GLOBAL SAFETY FIELD INVESTIGATIONS
DCS6624
URGENT - DISTRIBUTE IMMEDIATELY

Subject: N232404821 - Service Update
Mislabeled High Voltage Battery

Models: 2023 Chevrolet Bolt EV
2023 Chevrolet Bolt EUV
Equipped with Battery, Propulsion, Lithium- Ion Rechargeable Energy
Storage System (RPO EKZ)

N232404821 Mislabeled High Voltage Battery

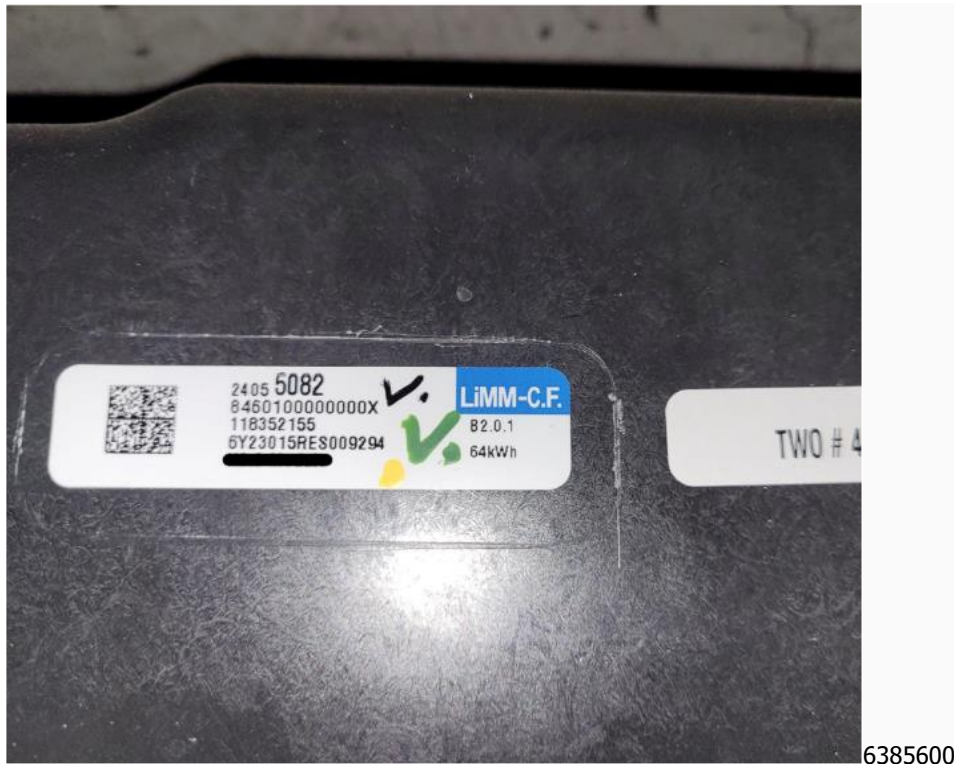
| Condition | Certain 2023 model year Chevrolet Bolt EV and Bolt EUV vehicles may have a condition in which the high voltage battery was shipped with incorrect labels. |
| Correction | Dealers are to use a black paint pen to obscure the N2.2 chemistry note on the Battery data label. |

- Using a sharpie, cross out the bottom line on the label that reads “N2.2 Module”. The modified label should look as above.

Note: Use care not to mark any other portion of the label. The other information on the label must remain legible for future serviceability.
